Solubility

The solubility of actinides is very important to calculating the releases from the repository. The CCA uses a model known as FMT to calculate these solubilities. EEG found that the model predicts differences for actinide sulfate solubilities that cannot be explained by chemistry, thus raising questions about the reliability of this model.

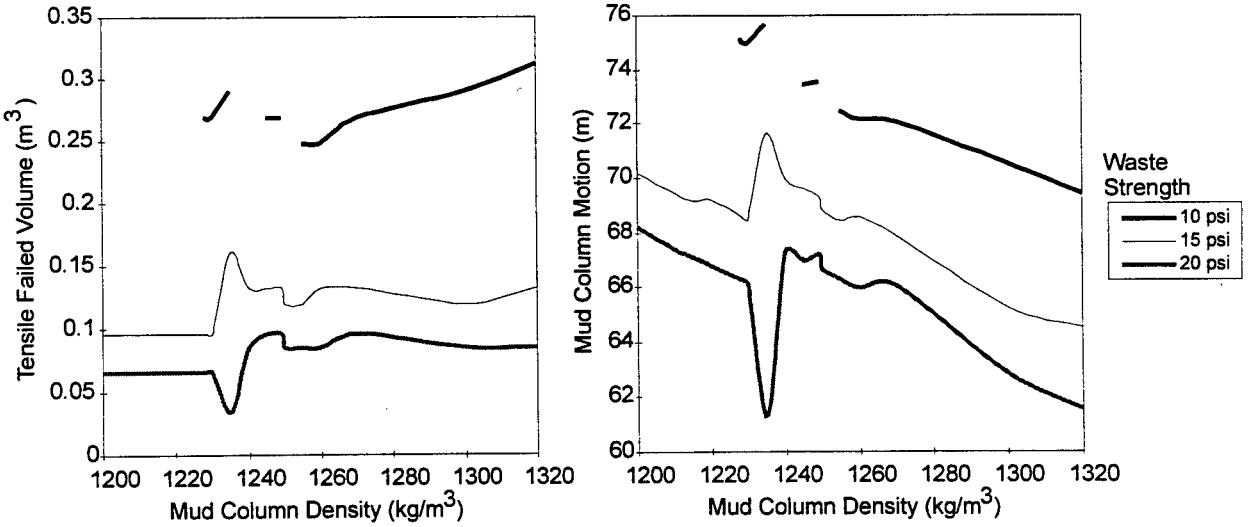
Figure 4 shows the results of varying the parameter from 1200 to 1320 kg/m^3 for a 10 second simulation and an initial repository pressure of 14.8 MPa. The figure shows three curves of different waste strength, with all other parameters remaining the same as used in the Base Case simulation. The most outstanding feature of Figure 4 is the disjointed curve of failed waste (left) and mud motion (right) of the 10 psi tensile waste strength simulation. The code had trouble calculating failed waste for mud densities below 1228 kg/m^3, resulting in the cascading affect described above. The code also had trouble at 1240 and 1250 kg/m^3, and if results were plotted for these densities (failed waste and mud motion), sharp spikes would exist in the curve.

For the higher waste strengths (and subsequently lower repository pressures) of 15 and 20 psi, the mud density simulations were able to calculate failed volumes for all density values investigated. However, the results seemed almost as unreliable as the lower waste strength. Though a trend can be seen in the failed volume and mud motion, variances from those trends are high. Both graphs in Figure 4. show trouble with densities between 1230 to 1270 kg/m^3.

Figure 7. Failure Volume (m^3) vs Time (s) for Different Waste Permeabilities. The results are from GASOUT with the option of 'failed material removal' turned off.

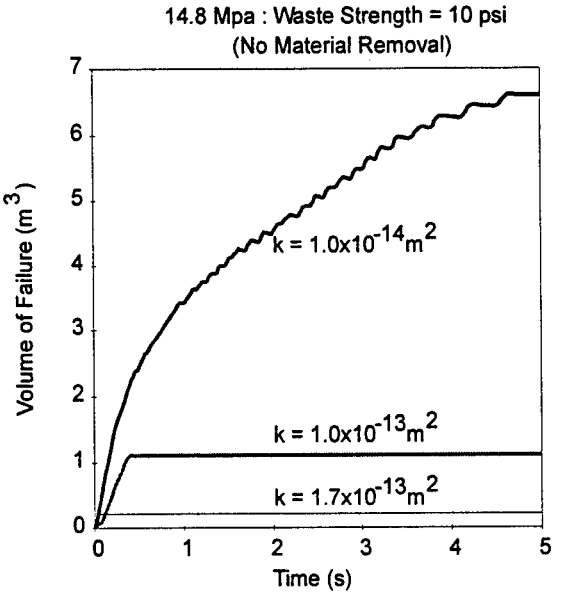
For an extreme example of the above analogy, Figure 7 shows radial distance of potential failure at permeabilities of $1.7x10^{-13}$ and $1x10^{-14}$ m^2 for pressures at 14.8 MPa without material removal. Potential failure was extrapolated from the effective stresses that would exist in non-failed material. The repository pressure was set at 14.8 MPa and waste strength at 10 psi for the experiments in Figure 7.

The figure clearly shows that when permeability is lower than assumed in the CCA then releases will be higher than assumed from the investigation in Hansen et al. (1997). The maximum radial failure at a permeability of $1x10^{-14}$ m^2 is 1.17 m, equating to an uncompacted spalled volume of 6.6 m^3. It is believed that when permeability is even lower than the lowest value presented in Figure 7, the releases could be higher. However, the code has difficulties with oscillations in pressures at lower permeabilities, and confidence in results is low.

The results of Figure 7 must be kept in context. When material is not removed during the pore pressure calculations (and subsequently total overburden stress), the code does not redistribute values at the new boundary. Instead, the pore pressures decrease in that region, hence lowering the possibility of new failed material. Therefore, Figure 7 actually underestimates the potential effect of failure, and higher volumes will result if the material is removed. These calculations are not possible with GASOUT, with reasons explained from the sensitivity analysis with the code.

Fig. 9. DOE's projected use of underbalanced drilling in the United States.

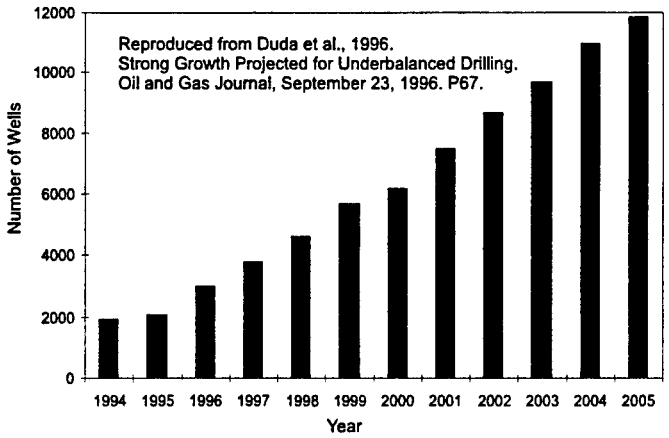
Bredehoeft did not limit his consideration of scenarios to a choice of drilling fluid. He observes that air drilling is a proven technology and its frequency of use by the oil and gas industry is increasing as shown in Figure 9. An examination of published materials shows that use of underbalanced drilling, including air drilling, is expanding in the oil and gas industry with the explicit support of the DOE Office of Fossil Energy (Duda et al, 1996) and strongly suggests that the analyses may need to include other methods of underbalanced drilling, including foam, mist, dust, aerated mud and light weight solid additives.

Figure 11. Effective Radial Stress As A Function Of Radial Distance For The EPA's Air Drilling Analysis.

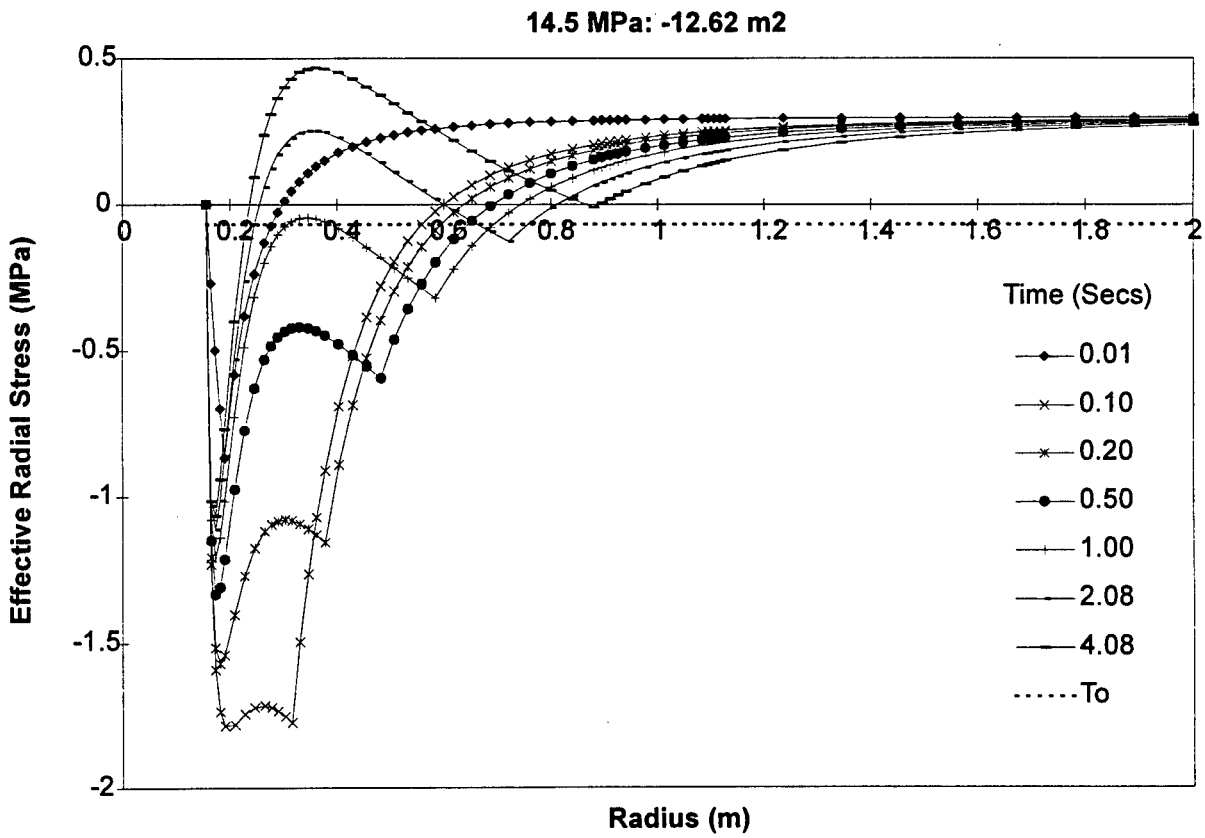
The results of air drilling from the EPA's analysis at WIPP is reproduced here in Figure 11. The figure shows effective stress versus radial distance within the repository at several times during the simulation. The EPA judged failure in this figure by estimating the point at which the effective stress is less than the strength of the material (indicating high pore pressure). This point is at 1 second from the beginning of the simulation, with a radial failure distance of 0.69 m (1.4 m^3 of uncompacted waste). After 1 second of simulation time, the pore pressure in the waste near the cavity begins to decrease, and the effective stress moves upwards (increases positively) towards the region of higher total stress.

Intuitively, the results shown in Figure 11 would raise questions about the behavior of the system. Why does the effective stress sharply decrease from 0.01 seconds to 0.1 seconds then gradually rise throughout the remainder of the simulation? Does the system stop predicting failure after 1 second? What is the effect of tangential stresses in the waste? How does the system respond to varying repository parameters? All of these questions are relevant to the understanding of the Quasi-Static model and to the prediction of stresses in the waste from an air drilling event.

Figure 12. Effective Stress, Total Stress, and Pore Pressure Profiles in the waste at three independent times from the EPA's Analysis of Air Drilling.

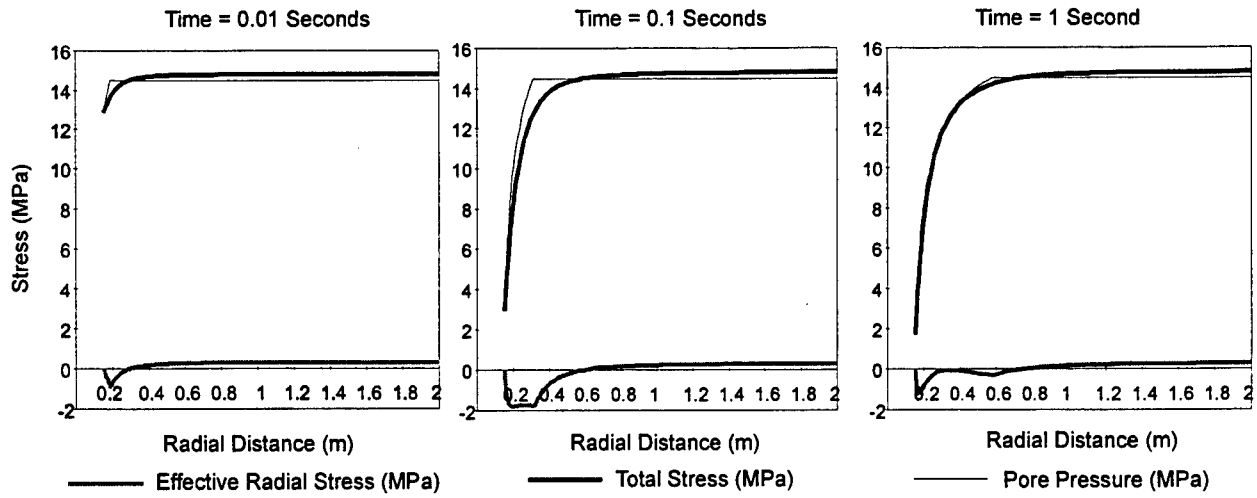
The effective stress is simply the difference in the calculated total stress and calculated pore pressure. Figure 12 shows the relationship between these quantities for three separate times for the EPA's analysis of air drilling. The left plot shows the first time step, at 0.01 seconds from time of intrusion. One can see immediately that waste failure occurs due to a slightly higher pore pressure, with the radius of failure being 0.27 m. The relatively large failure at this time is due to the unsmooth function of the pore pressure in the waste, which carries over to the effective stress. The same can be seen the two other plots of 0.1 and 1 second from intrusion time. The effects of the unsmooth pore pressure profile average out as the time from intrusion increases, but is one the reasons for increase in effective stress at later times.

The code also only approximates the pore pressures in the repository by assuming steady flow. As seen in Figure 12 (above), the steady flow assumption causes the pore pressure profile to be unsmooth. This characteristic, when combined with total stress of the overburden rock, produces oddly varying effective stresses in the waste. This shows that the code produces unreliable results for an air drilling scenario. When effective stresses are compared to the results of a code that calculates the time-dependent flow and pore pressures (Figure 13, above), the effective stresses are much lower (higher in the negative direction) than the Quasi-Static model at early times. Beyond the first couple of time steps, the code starts to be less accurate, and pore pressures begin to decrease in waste that should have been removed.

Figure 13. Effective Radial Stress As A Function Of Radial Distance Using GasOut For The Air Drilling Analysis.

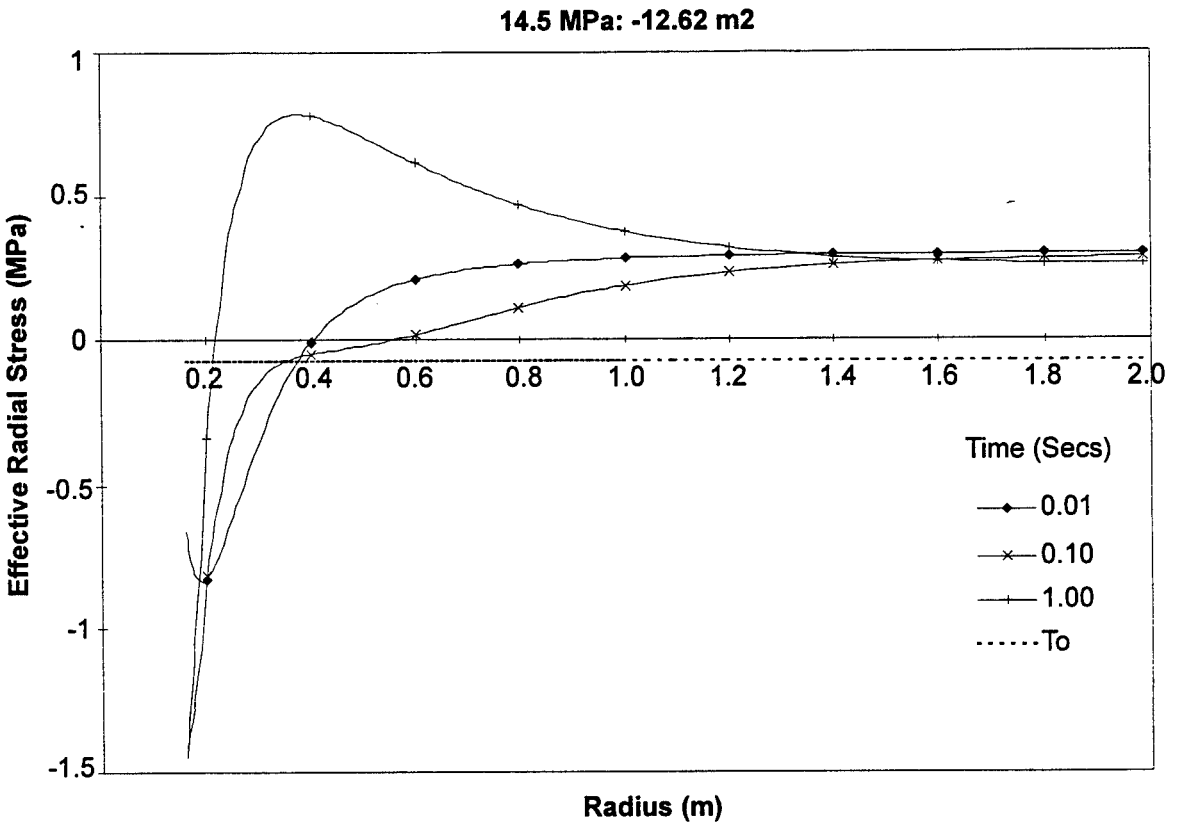
shows the effective stresses as calculated in GASOUT from an air drilling scenario. The code was run with the cavity growth option turned off and the same input assumptions as used in the Quasi-Static model. Although the code cannot predict failure accurately with the option of failed material removal to be removed (due to multiple layers of cascading waste during a single time step), the code can calculate the pore pressure distribution and effective radial stresses that match quite closely to the Quasi-Static model with the option turned off. Figure 13 shows that at 0.01 seconds from intrusion time, the radial failure is 0.38 m, which is higher than the Quasi-Static model. Although, it must also be noted that the pore pressure eventually decreases after this initial time, at 0.1 and 1 second from the time of intrusion. The conclusion gathered from this analysis is that the pore pressures are smooth through the waste, and subsequently predicts a much higher negative effective stress at earlier times.

the drilling fluid. The curve showing that material is removed has higher pore pressures in the waste. Though the difference in pressures between the two curves is slight, it would have a significant impact on the effective stresses and potential releases. For Figures 1 and 3 above, the pore pressures artificially decrease from the flow of gas in material that should have been removed. Therefore, the judgment of waste failure from Figure 11 leads to false confidence by underpredicting waste failure.

Figure 14. Yield Potential for EPA Air Drilling Analysis. The Figure Represents Equation 2 (above) vs. Radial Distance. Yield Will Occur When the Potential is Greater than Zero.

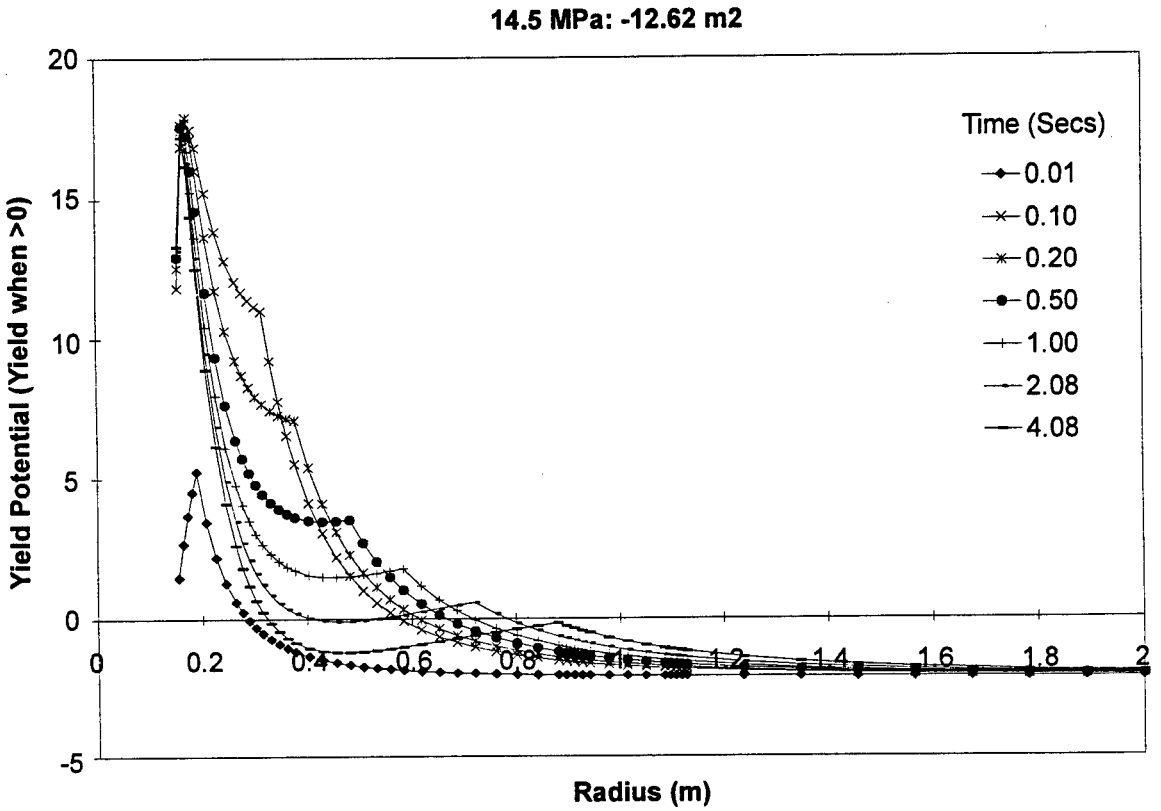
Figure 14 shows the results of Equation 2.5-2 plotted against radial distance. The first observation is that there is potential for yield out to 2 seconds from the time of intrusion. The yield crosses the axis at approximately 0.8 m, resulting in an uncompacted volume of 2.1 m^3. This is an increase of 33% from the initial estimate stated in the EPA's analysis. The curves also seem to be highly influenced by the discontinuity in pore pressure calculations, and can be seen in Figure 14 by the second peak in the curve as radial distance increases. When compared to the yield potential calculated from GasOut, which calculates a smooth function of pore pressure, the limit for yield is 0.7 m at 0.1 seconds from intrusion (as compared to 0.6 m from the Quasi-Static model). After this time the yield is essentially zero.

Figure 15. Effective Radial Stress As A Function Of Radial Distance For An Increased Pressure For The Air Drilling Scenario.

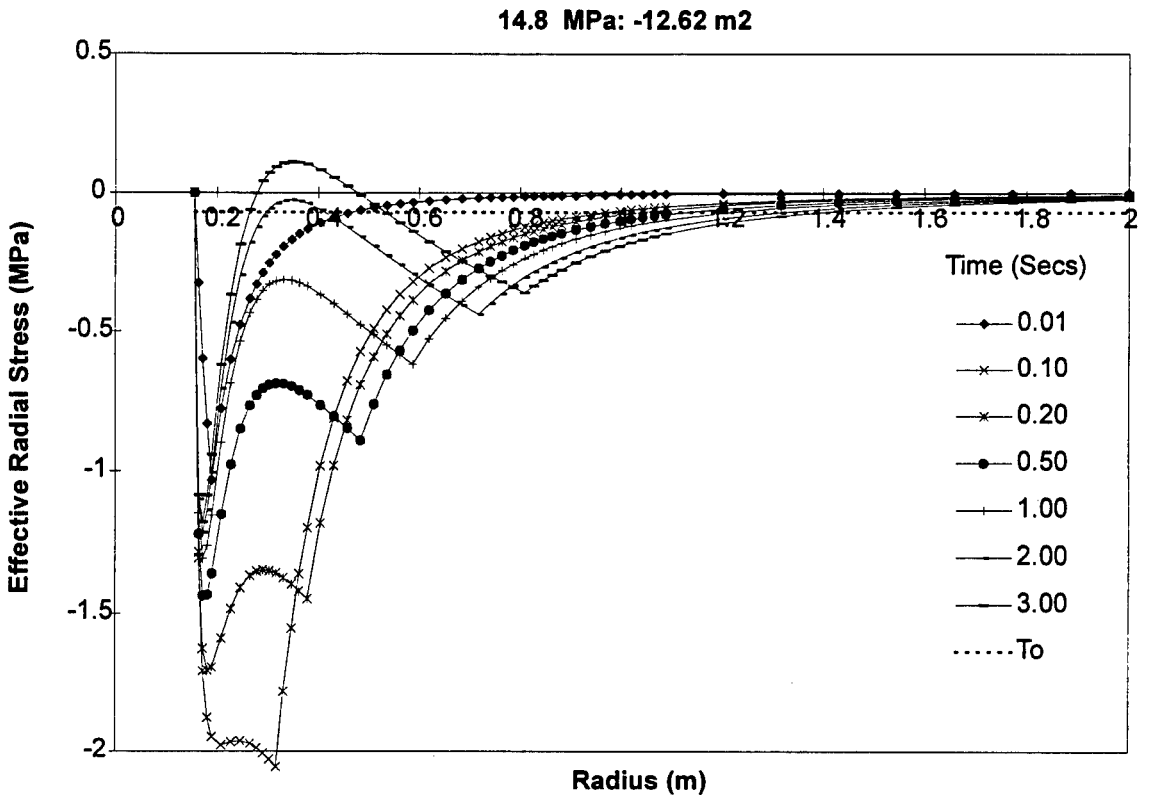
To demonstrate the response of the model to different input assumptions, Figure 15 shows a simulation in which the repository is increased from the nominal 14.5 MPa that was used in the EPA analysis to 14.8 MPa. The higher pressure is the maximum pressure that the repository will

sustain for long periods of time, and is the lithostatic pressure of the overburden rock. If gas pressures are above lithostatic, the weak stratigraphic layers will fracture until sufficient energy is released and the pressure returns to the minimum fracturing pressure. The results of Figure 15 are astounding. The figure shows that a nominal increase in pressure will significantly increase potential releases. At 1 second after initial intrusion, the radial distance of failure is 1.22 m (7.58 m^3 of uncompacted waste). Although not shown, the waste will continue to fail during the entire 9 second simulation, in which the radial distance increases to approximately 1.65 m (19.1 m^3 of uncompacted waste). These volumes are greater than the 4.0 m^3 maximum calculated in the CCA, and perhaps would have an impact on the CCDF calculations if air drilling scenarios were considered in the CCA.

Fig. 19. Comparison of Approved Injection Pressures For Salt Water Disposal Well Versus Oil Field Water Flood Wells Near WIPP.

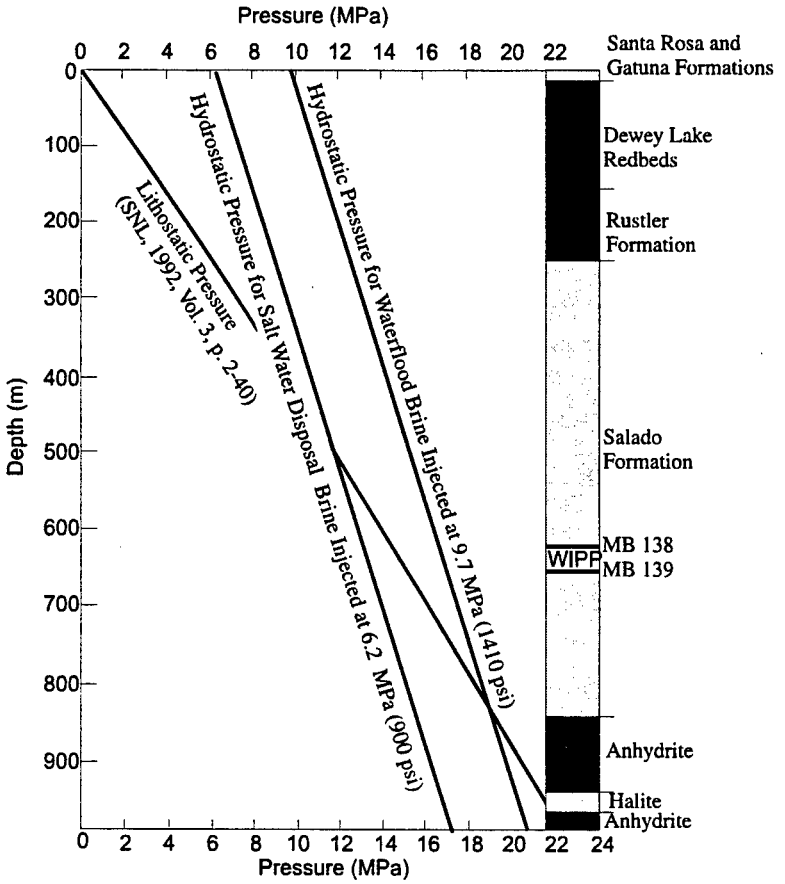
of the WIPP. Figure 19 compares the maximum approved disposal pressure for two wells one mile to the east of the WIPP Site. EEG is not suggesting that either of these wells are leaking. But EEG notes that in the event of a leak near WIPP current approved salt water disposal pressures are not sufficient at the repository horizon to exceed the lithostatic pressure. Only the a leak in the waterflood well would be of concern to the repository. This is an inherent result of the greater vertical distance to the oil producing horizons. The DOE and EPA rationale appears to be more appropriate for the more shallow oil and gas reservoirs in the Vacuum Field area and the Rhodes Yates area and not suitable for the WIPP area. Presumably, carbon dioxide for enhanced oil recovery would be injected into the deeper oil producing zones and at sufficient pressures to maintain a miscible displacement. Hence, given the observation above, EPA can not conclude that the salt water disposal well analyses captures the CO_2 flooding scenario.

Fig. 21. Permeability vs. Porosity Model With BRAGFLO for Left) Marker Bed 139 and Right) Marker Beds a and b.

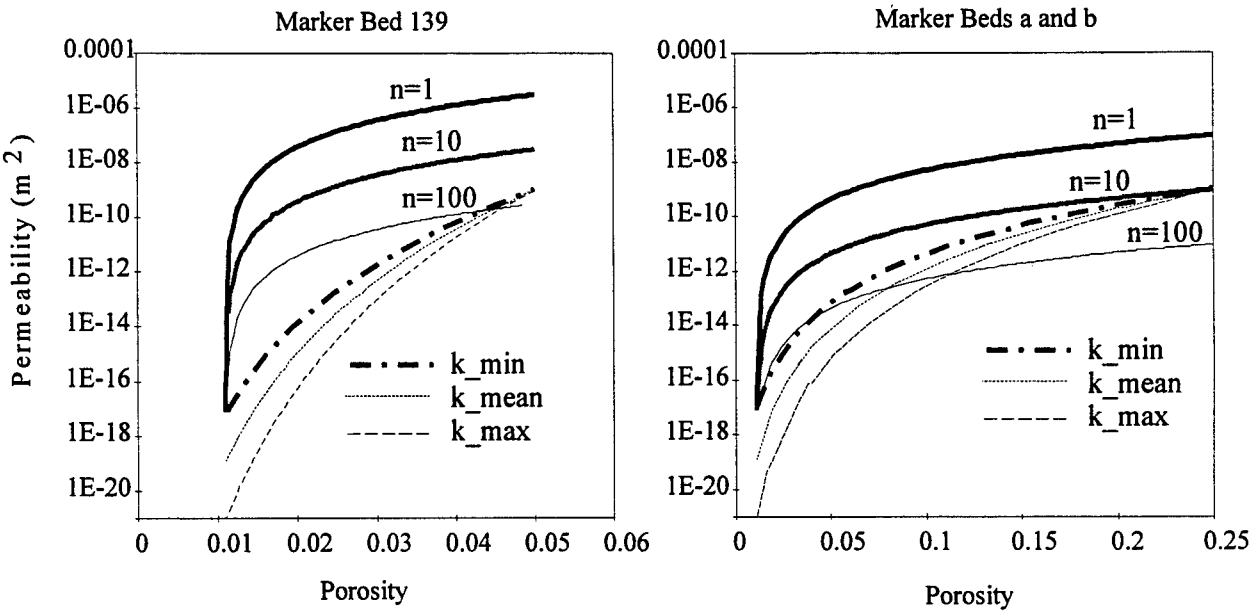
Our conclusion is that the conceptual model BRAGFLO for anhydrite fracturing may be a valid description for pore pressures less than 1 MPa below lithostatic but a cubic law formulation of the permeability-porosity relationship is valid above this threshold. As demonstrated by Freeze et al. (1995), the BRAGFLO parameters can not be set to reasonably represent this region. Figure 21 is an updated version of Figure 2 of Freeze et al. (1995). The BRAGFLO model is based on CCA parameters for marker bed 139 and anhydrite layers A and B respectively. The figure shows the permeability-porosity relationship of the BRAGFLO model to a cubic law based model for multiple fractures. Our concern is that the BRAGFLO model under-represents permeability by more than four orders of magnitude for small porosity increases. By setting the model parameters to match a cubic law fracture model at large .porosity, a large error may have been introduced for small porosity changes.
